DART SERVICE INSTRUCTION

TO AMEND INSTALLATION INSTRUCTIONS I1145-6 REV A, AND
INSTRUCTIONS FOR CONTINUED AIRWORTHINESS ICA145-5 REV N/C
REF. TCCA STC: SH21-24
REF. EASA STC: 10077436
REF. FAA STC: SR04694NY

The purpose of this Service Instruction is to provide clarity on the trimming of the FWD end of the girts on the P/N 646.5405/5406 fwd floats used in the 654.6700 float kits for compatibility with the Airbus Hoist Cable Guards and to provide a disposition on girts that have been trimmed with a sharp corner.

FIGURE 1: REWORK TO NEW FLOATS (BOTH SIDES OF GIRT)

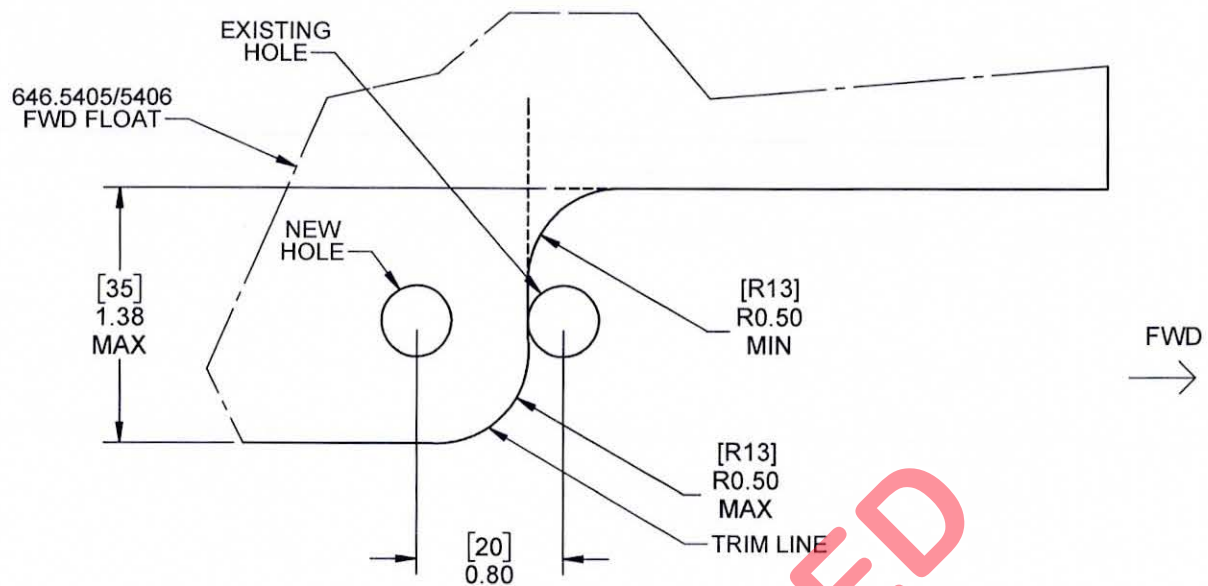
1. For P/N 654.5405/5406 fwd floats that have NOT been trimmed for the Airbus Hoist Cable Guards, it is acceptable to trim to the back of the FWD hole in the girt with a minimum 0.50" (13 mm) radius as shown in Figure 1. The FWD hole must be relocated 0.80" (20 mm) aft of the existing FWD hole in the girt.
2. For P/N 654.5405/5406 FWD floats that have already been trimmed per Figure 2, these must be reworked according to Figure 3 in order to introduce a minimum 0.50" (13 mm) radius in the cutout.
